The Piggott School

GROUND FLOOR
(PHASE 1) DINING
EXISTING

PGT-HLM-P1-00-DR-A-00171

PCA MarkUp 220525_ HLM Planning Drawings

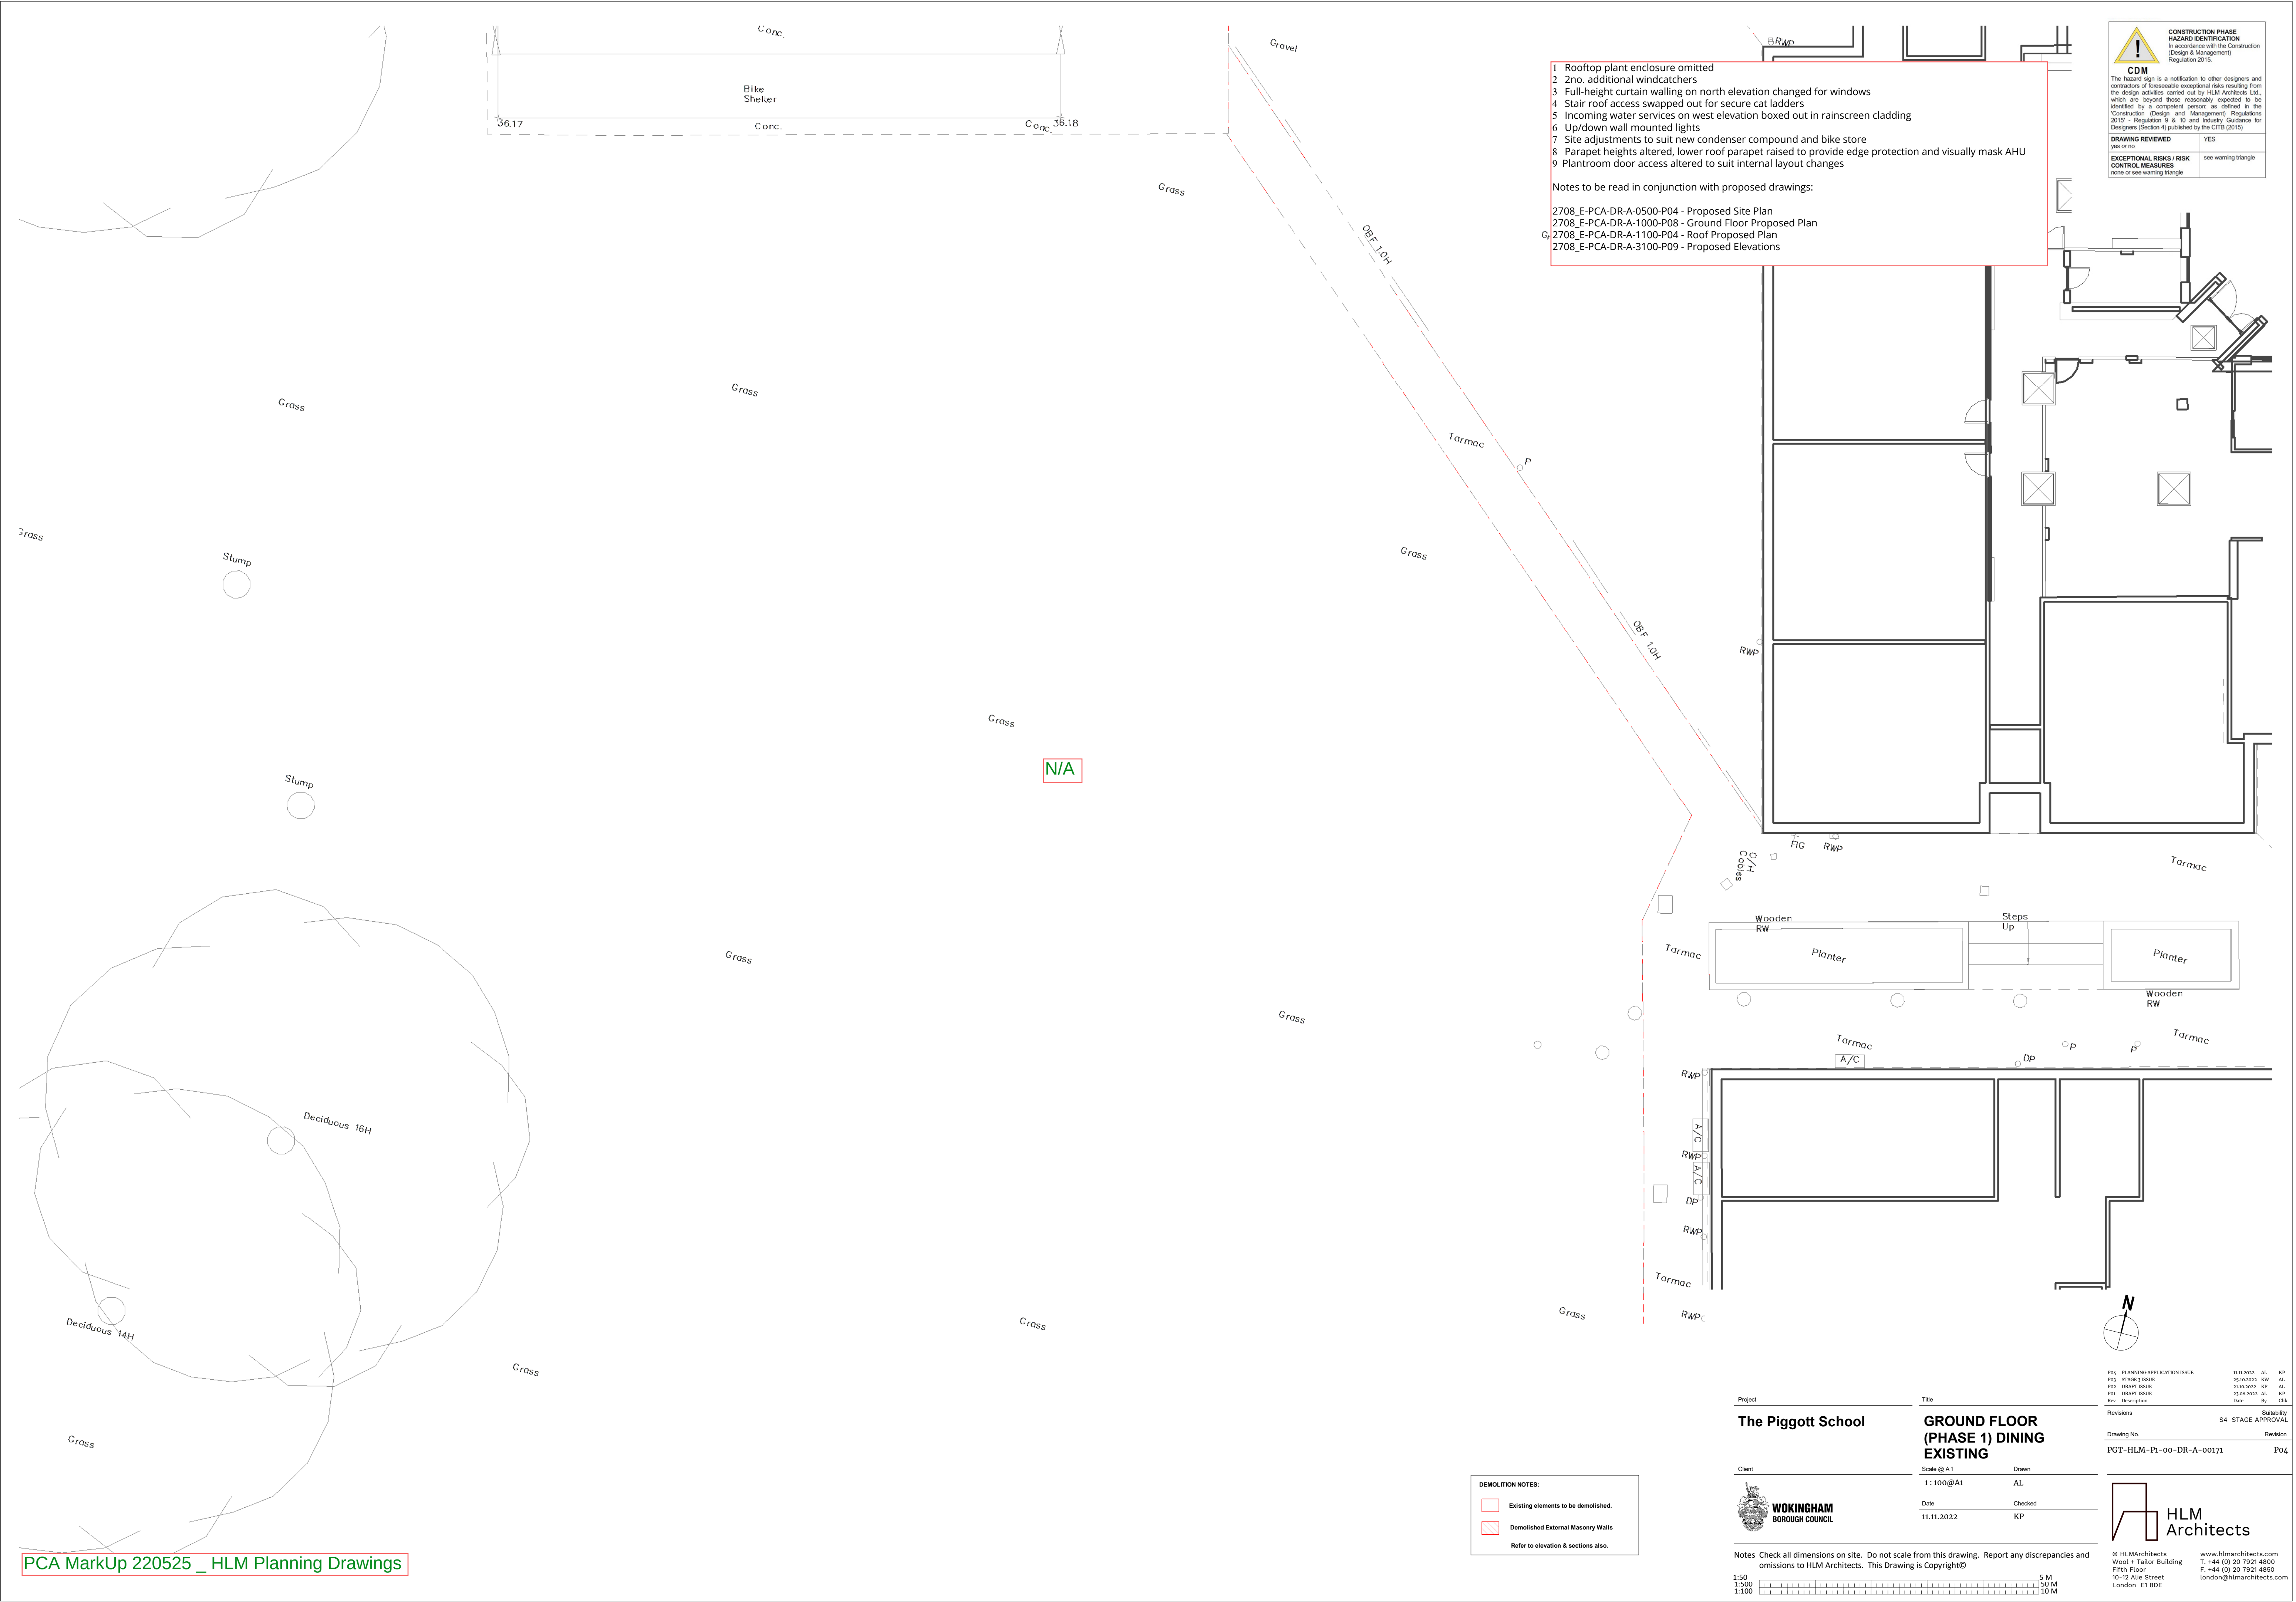
- 1 Rooftop plant enclosure omitted
- 2 No. additional windcatchers
- 3 Full-height curtain walling on north elevation changed for windows
- 4 Stair roof access swapped out for secure cat ladders
- 5 Incoming water services on west elevation boxed out in rainscreen cladding
- 6 Up/down wall mounted lights
- 7 Site adjustments to suit new condenser compound and bike store
- 8 Parapet heights altered, lower roof parapet raised to provide edge protection and visually mask AHU
- 9 Plantroom door access altered to suit internal layout changes

Project	The Piggott School		Title	ROOF PLAN (PHASE 1) DINING PROPOSED			
Client	 WOKINGHAM BOROUGH COUNCIL		Scale @ A1	1:100@A1	Drawn AL		
			Date	11.11.2022	Checked KP		
			Revisions				
			S4 STAGE APPROVAL				
			Drawing No.	PGT-HLM-P1-RF-DR-A-00131	Revision P04		
			 HLM

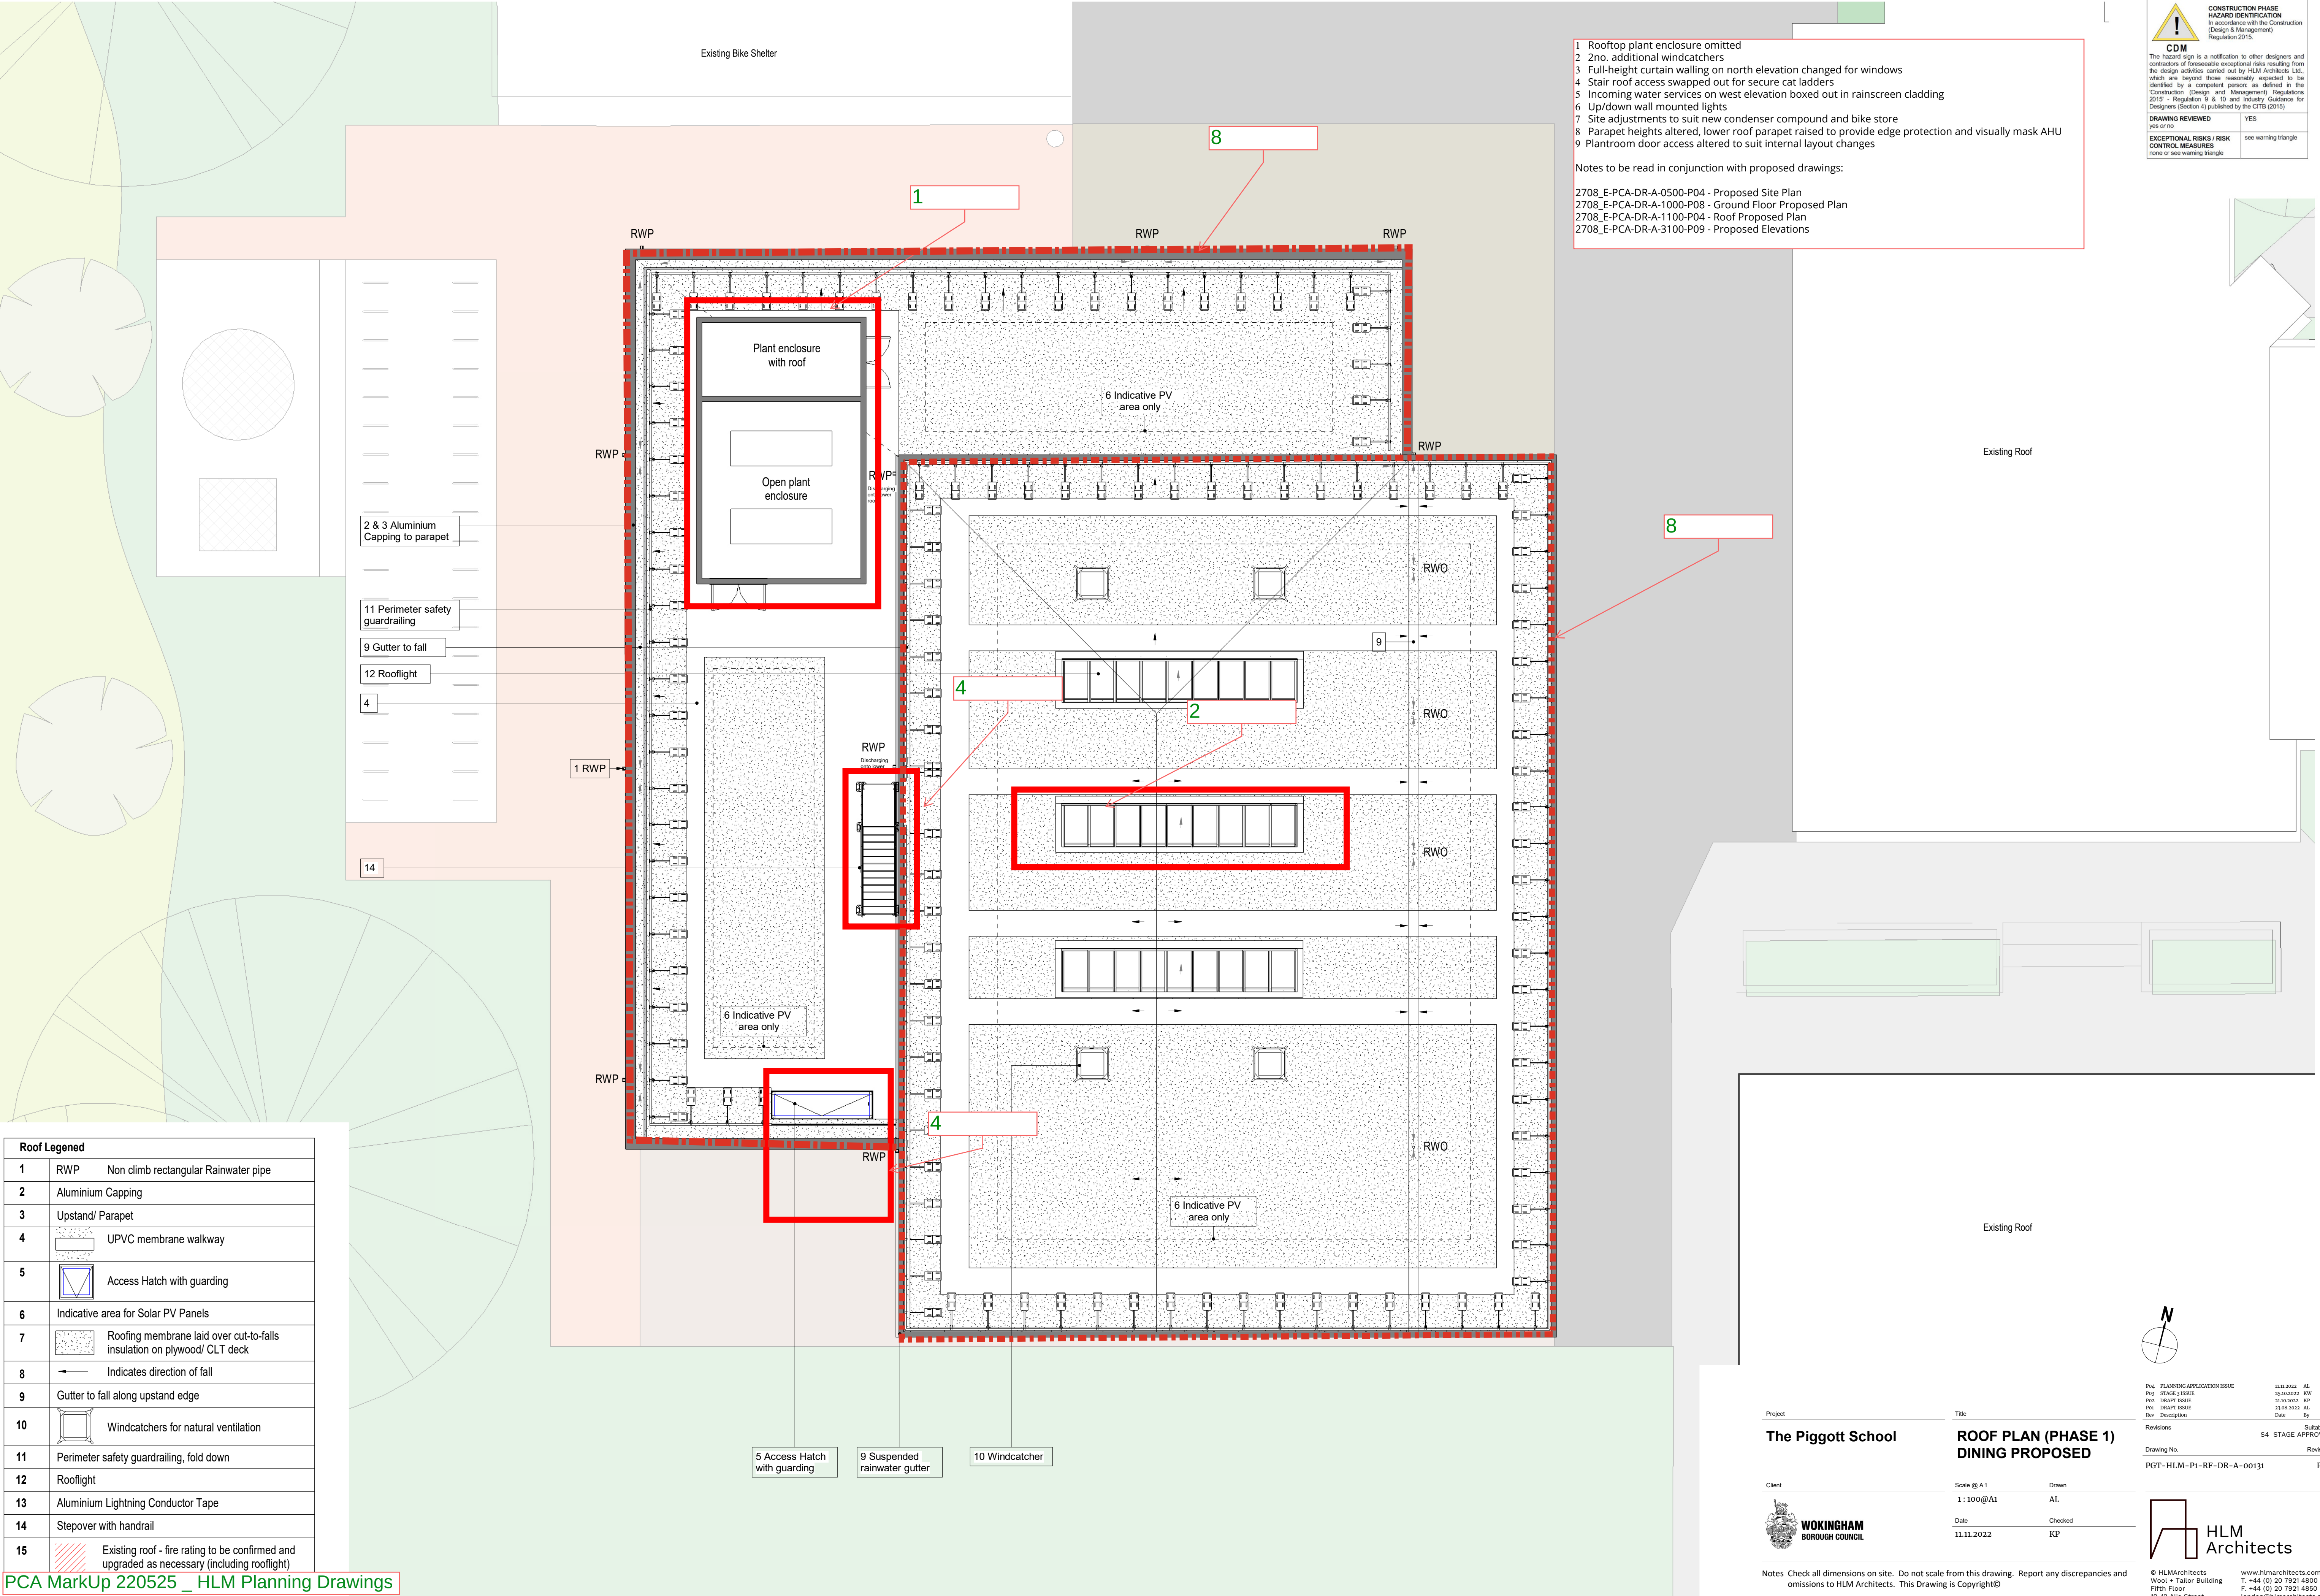
- 1 Rooftop plant enclosure omitted
- 2 No additional windcatchers
- 3 Full-height curtain walling on north elevation changed for windows
- 4 Stair roof access swapped out for secure cat ladders
- 5 Incoming water services on west elevation boxed out in rainscreen cladding
- 6 Up/down wall mounted lights
- 7 Site adjustments to suit new condenser compound and bike store
- 8 Parapet heights altered, lower roof parapet raised to provide edge protection and visually mask AHU
- 9 Plantroom door access altered to suit internal layout changes

PGT-HLM-P1-XX-DR-A-00201

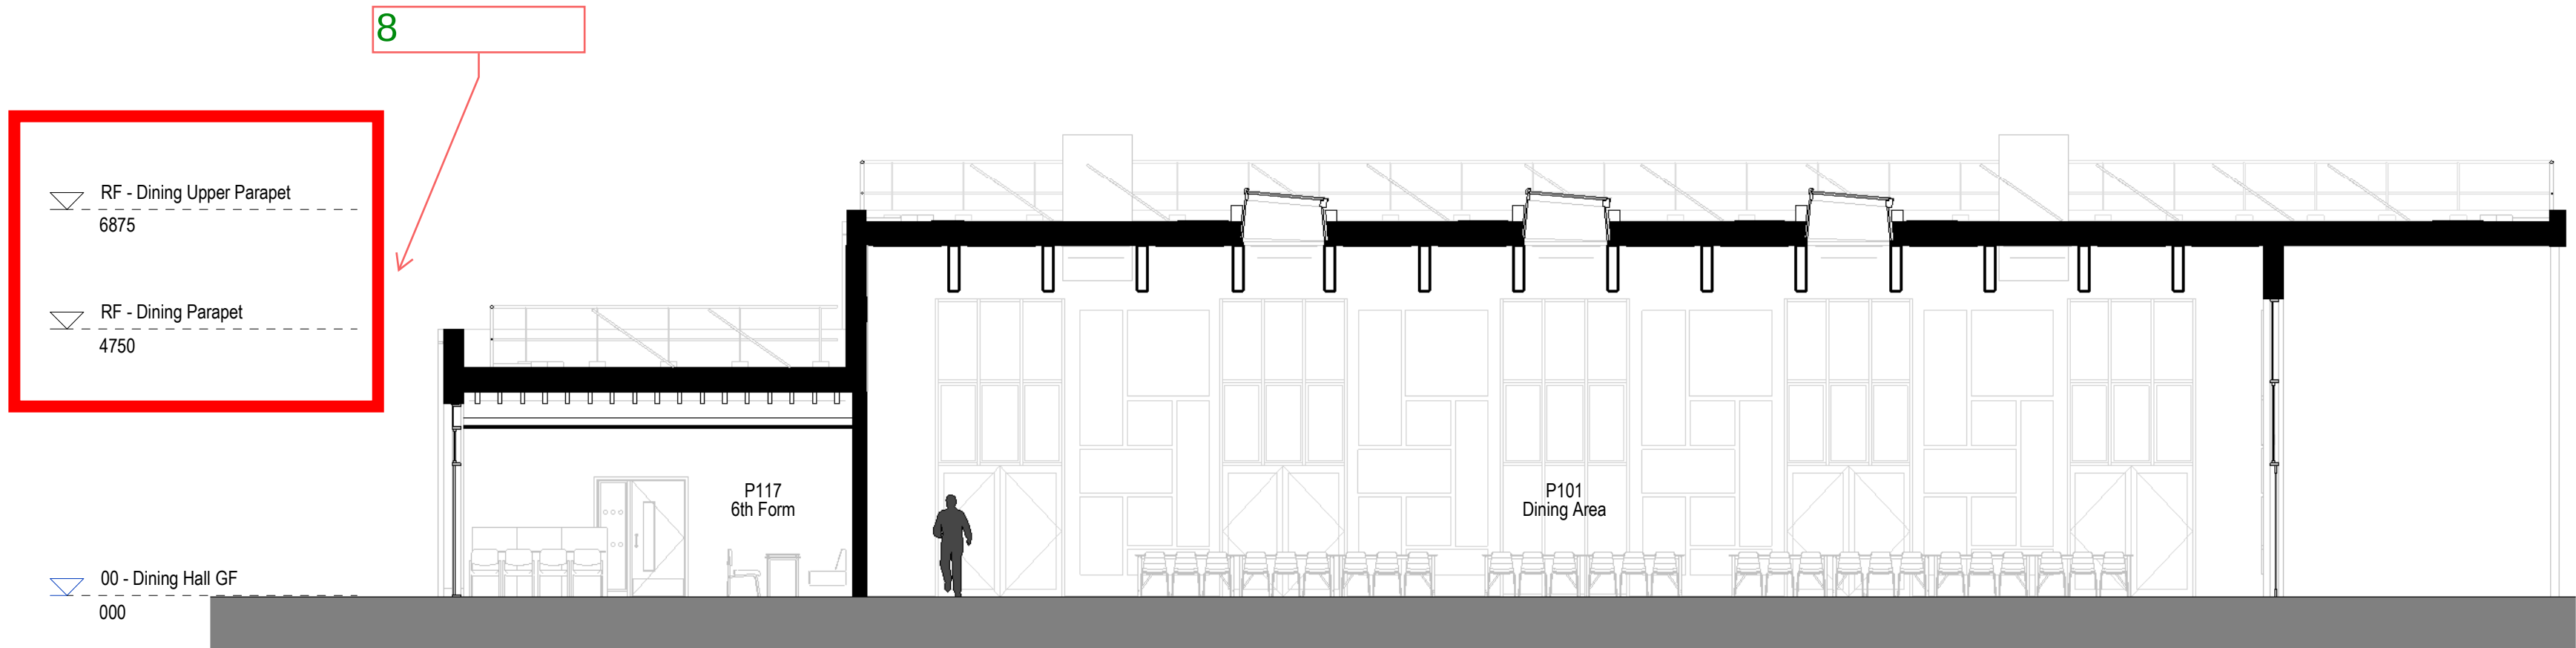
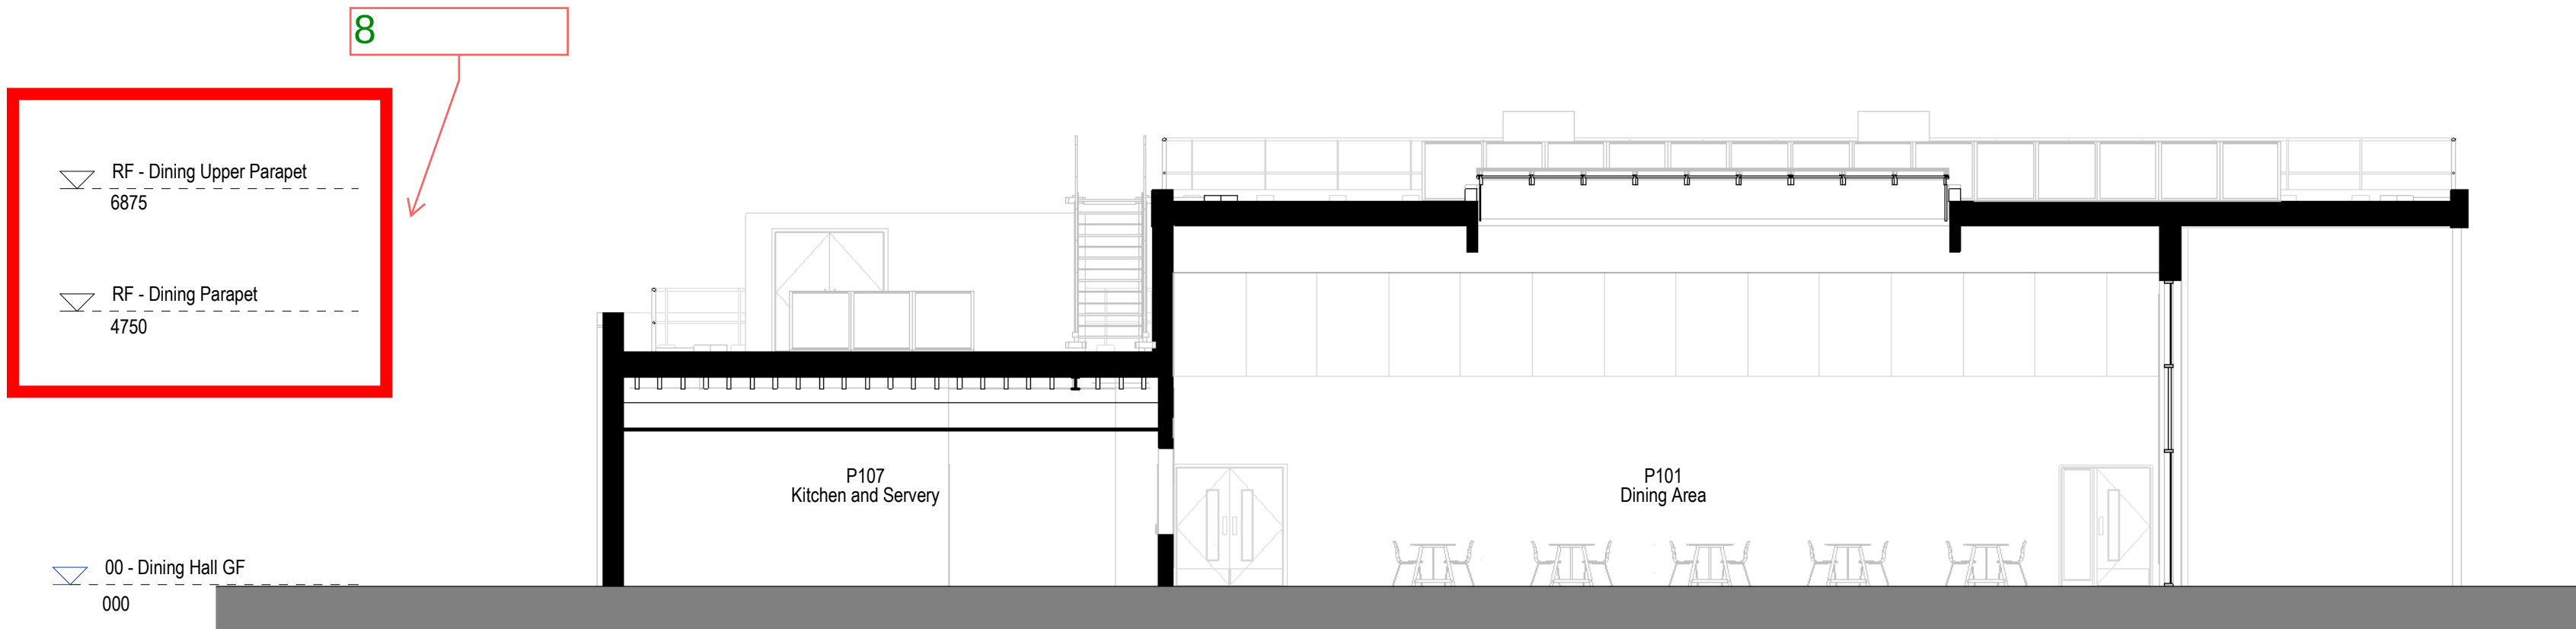
- 1 Rooftop plant enclosure omitted
- 2 2no. additional windcatchers
- 3 Full-height curtain walling on north elevation changed for windows
- 4 Stair roof access swapped out for secure cat ladders
- 5 Incoming water services on west elevation boxed out in rainscreen cladding
- 6 Up/down wall mounted lights
- 7 Site adjustments to suit new condenser compound and bike store
- 8 Parapet heights altered, lower roof parapet raised to provide edge protection and visually mask AHU
- 9 Plantroom door access altered to suit internal layout changes
